Marin County Flood Control and Water
Conservation District
**Corte Madera Creek Flood Risk Management
Project, Phase 1**
Final Environmental Impact Report
Volume 1: Comments and Responses to Comments
State Clearinghouse No. 2020080353

**Marin County Flood Control and Water
Conservation District
Corte Madera Creek Flood Risk Management
Project, Phase 1
Final Environmental Impact Report
Volume 1: Comments and Responses to Comments
State Clearinghouse No. 2020080353**

Figure 2-13 Alternative 1 Changes in Water Surface Elevation Year 2100, 10-Year Flood Event (Upper Corte Madera Creek)

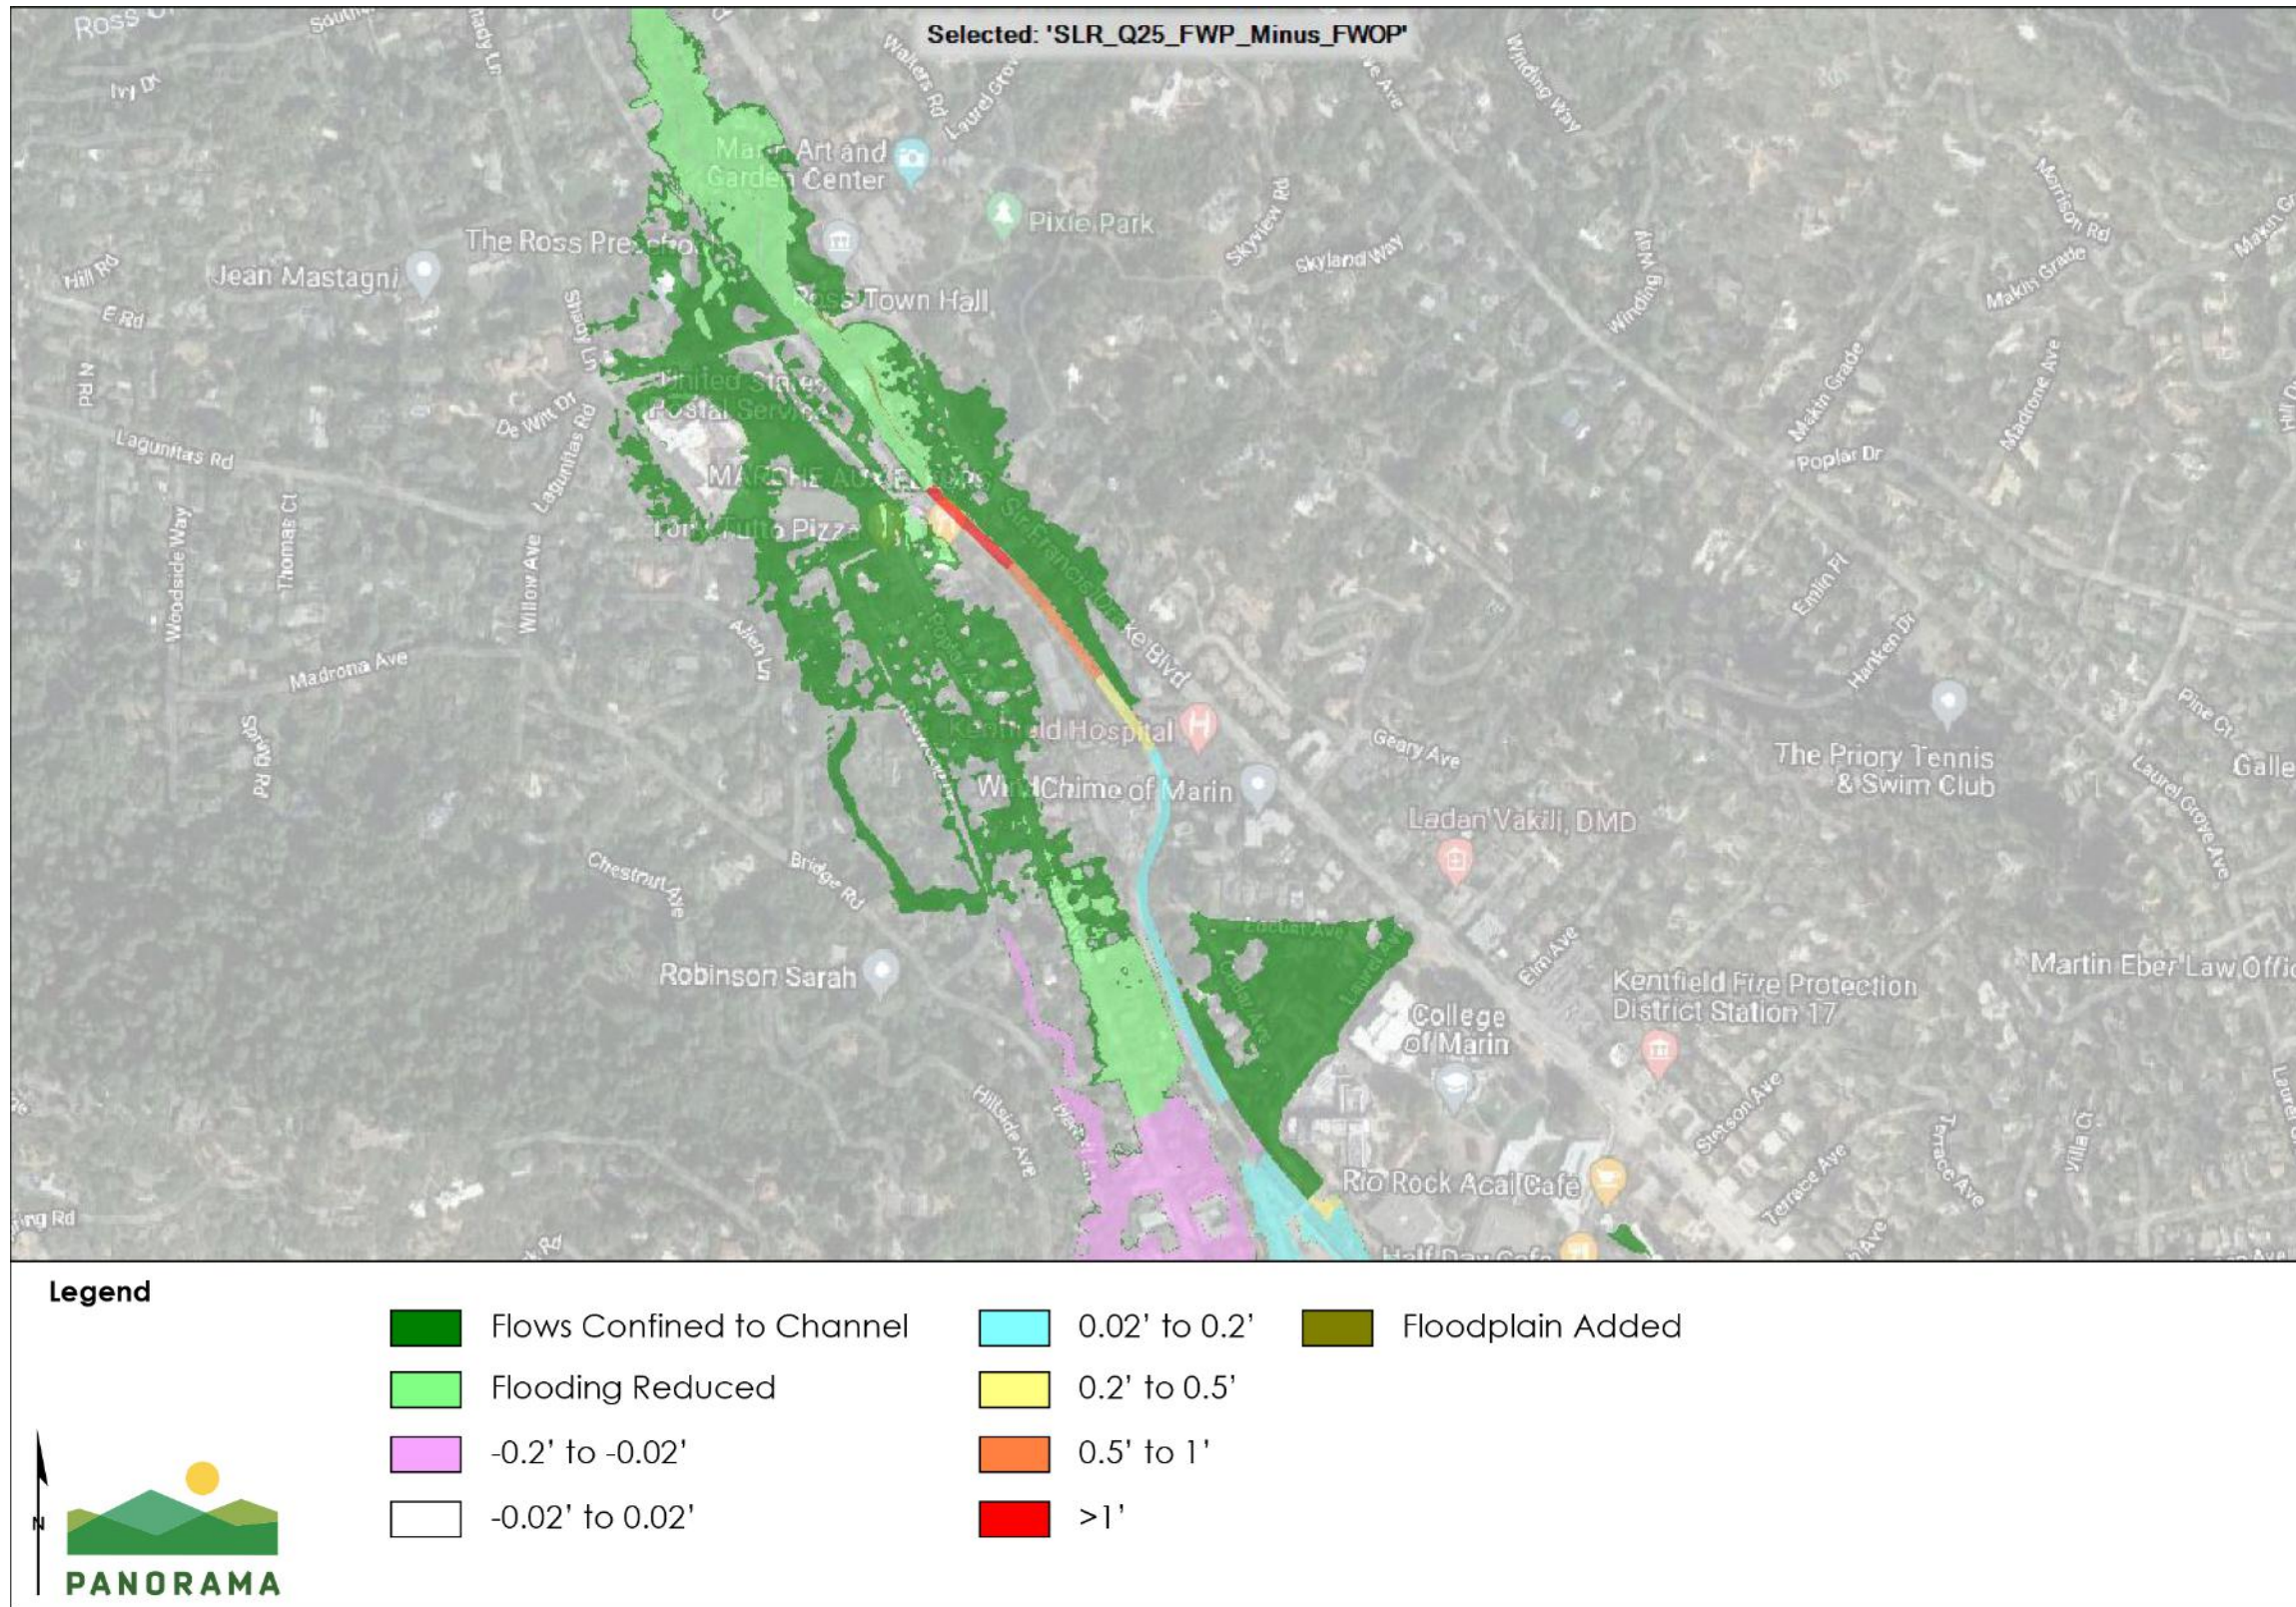
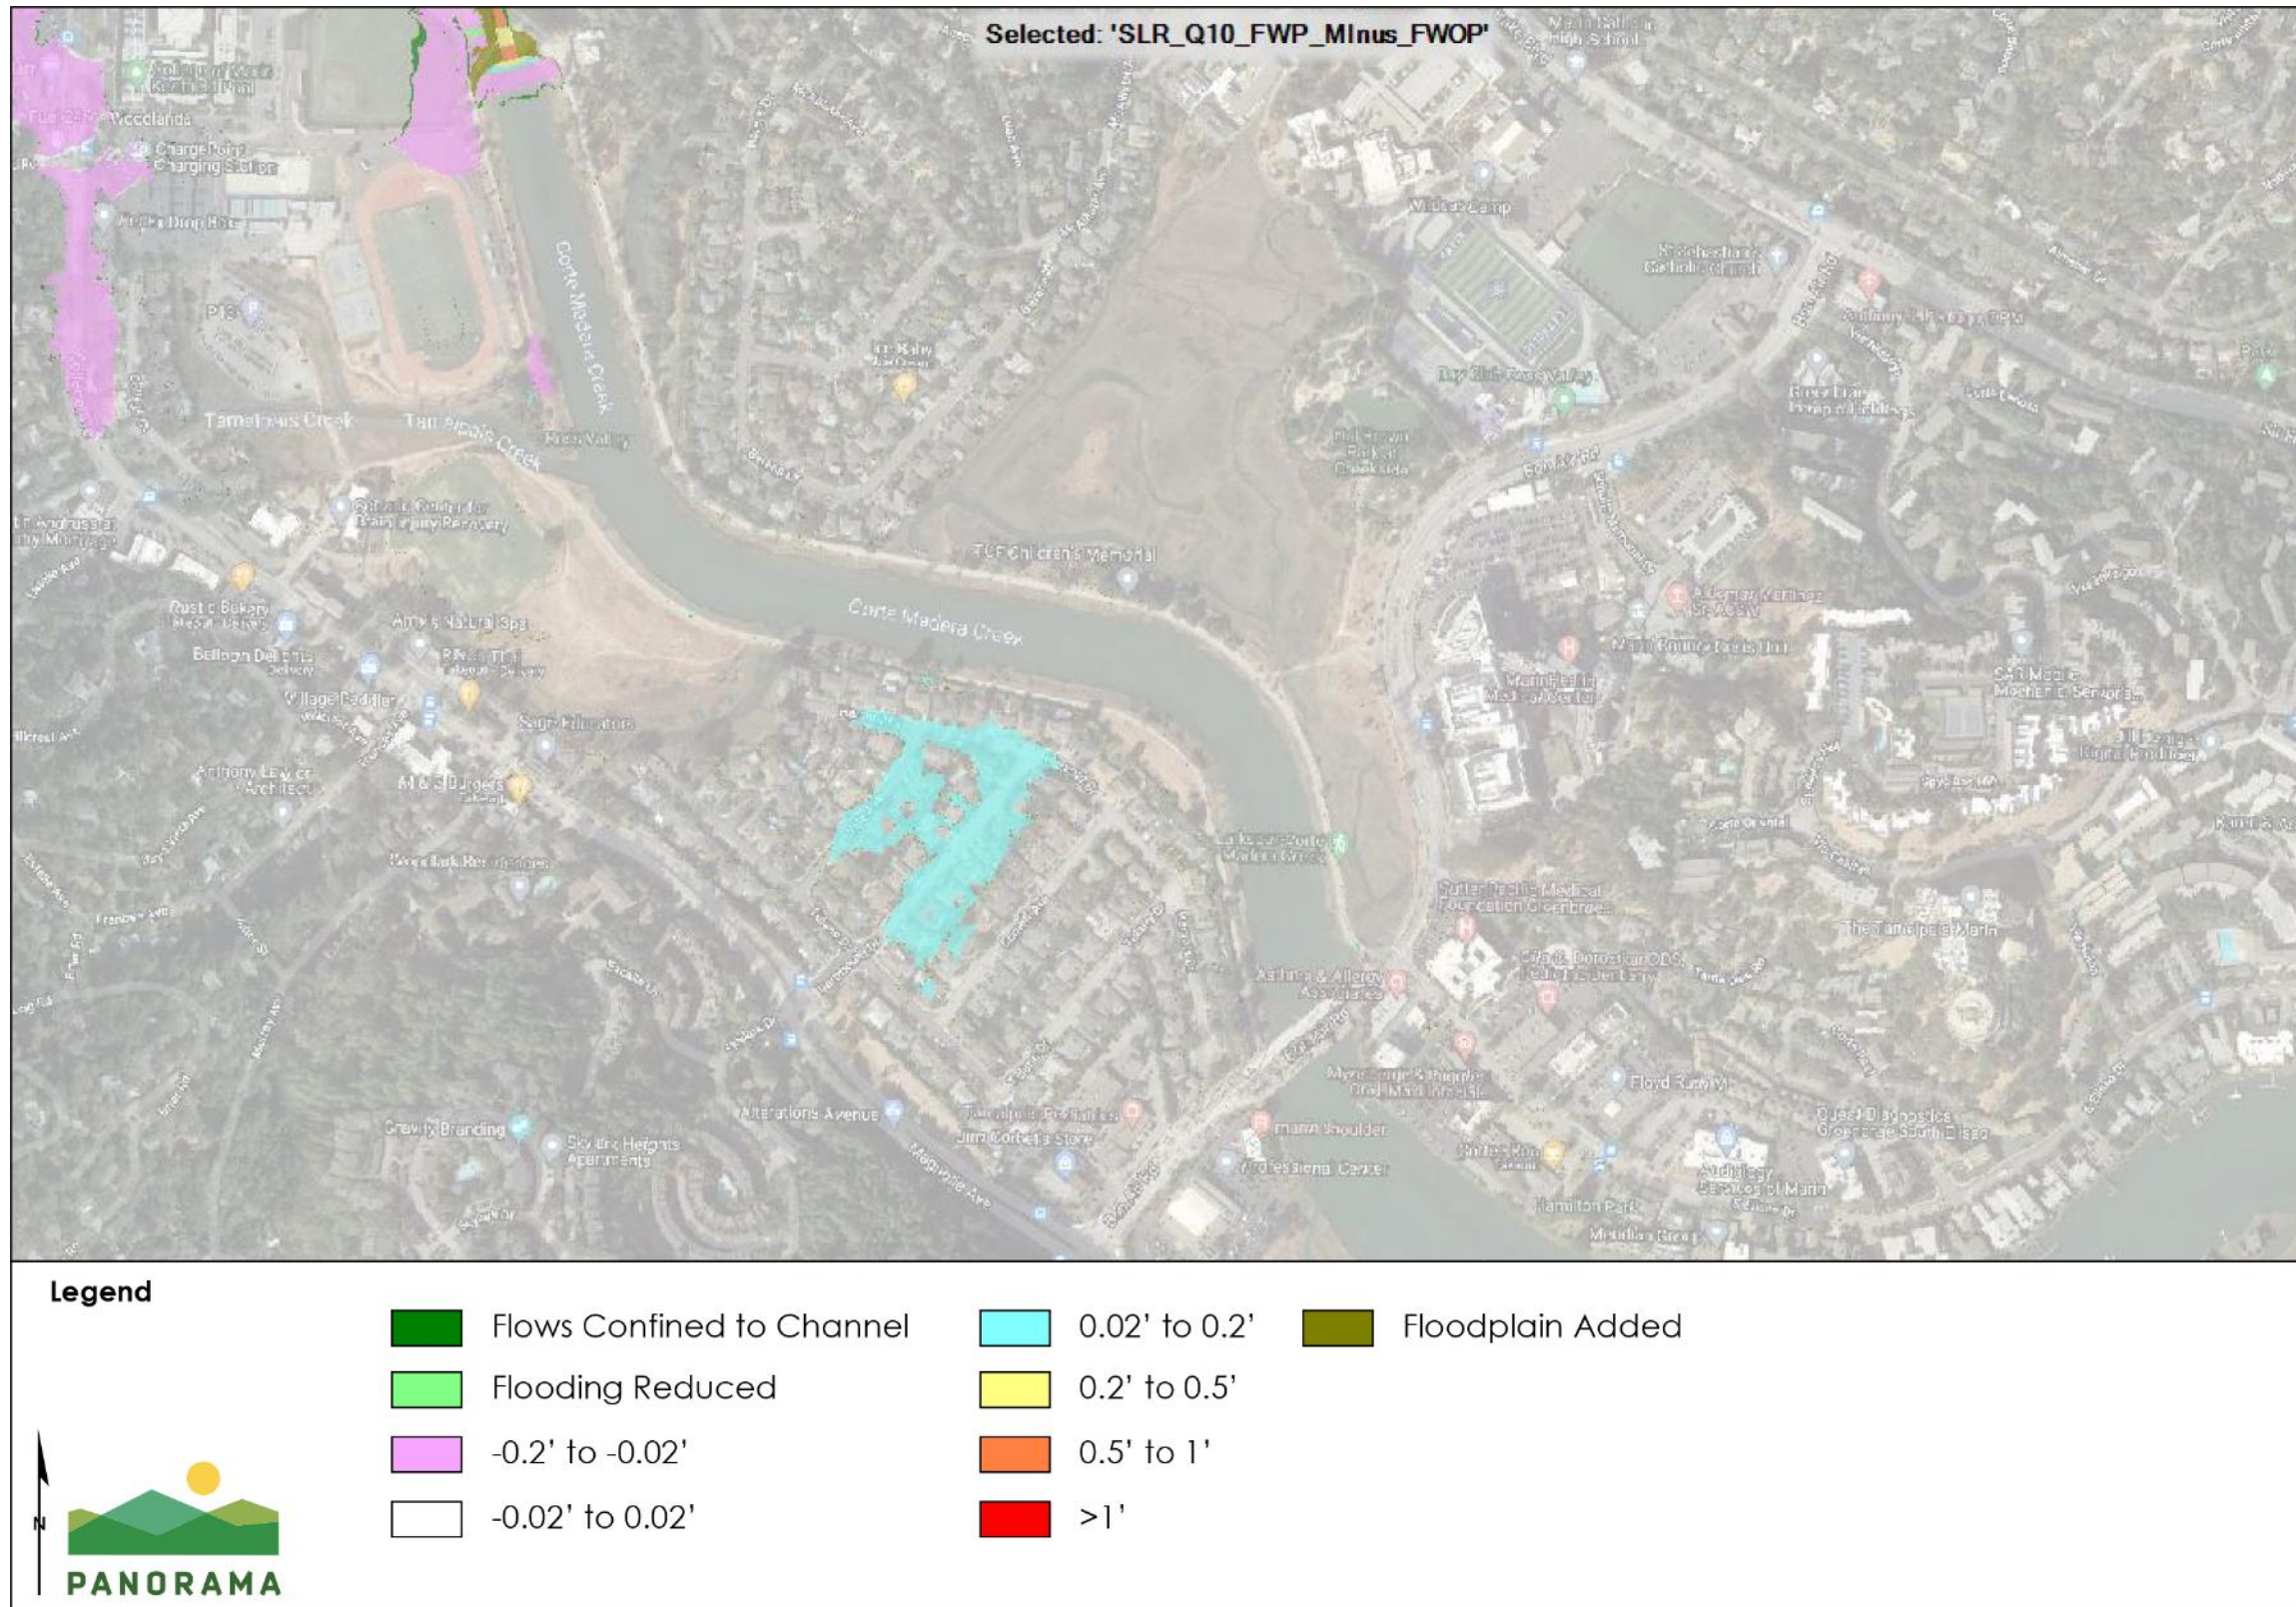
The geographic extent of the figures showing the changes in WSE differs from the figures included in the Draft EIR. The geographic extent of the figures was expanded to show areas downstream from Unit 2 in response to comments from the City of Larkspur. As discussed on page 3.9-39 in the Draft EIR, a threshold of 0.2 foot (2.4 inches) was used for determining whether a potentially significant increase or decrease in WSE would occur at any structure. The 0.2-foot threshold is a reasonable level of precision for evaluating flooding impacts, considering the standards for accuracy and precision associated with hydraulic modeling.

Figure 2-1 through Figure 2-6 show the Alternative 1 changes to the WSE and reflect the difference in WSE between the Existing Condition Without Project and Existing Condition With Alternative 1 scenarios under a 10-, 25-, and 100-year flood, using the updated modeling for the 60 percent design. Figure 2-7 through Figure 2-12 show the Alternative 1 changes to the WSE under for the future condition scenario, and reflect the difference in WSE between the Future Condition Without Project and Future Condition With Alternative 1 under the 10-, 25-, and 100-year flood conditions. The assumptions used in the future condition modeling are described on pages 3.9-35 through 3.9-37 in Section 3.9 in the Draft EIR and are supplemented by the model updates described above. Figure 2-13 through Figure 2-18 show the Alternative 1 changes to the WSE under a “high-emissions likely” sea-level rise scenario, to reflect 2100 projected sea-level rise based on the 2018 Update of the State of California Sea-Level Rise Guidance (California Ocean Protection Council, 2018). Figures 2-13 through 2-18 reflect the difference in WSE between the Year 2100 Future Condition Without Project and Year 2100 Future Condition with Alternative 1 scenarios under the 10-,25-, and 100-year flood conditions.

Areas shown in the figures as “Flows Confined to Channel” are areas that are currently flooded by Corte Madera Creek, which are predicted to no longer have flood inundation from Corte Madera Creek overtopping after Alternative 1 is implemented. Areas shown in the figures with “Flooding Reduced” are areas with reduced flood inundation (greater than 0.2 foot) from creek overtopping after Alternative 1 is implemented. The change in WSE shown on the maps reflects a comparison between WSE without implementation of Alternative 1 and the WSE after implementation of Alternative 1 for each modeled scenario.
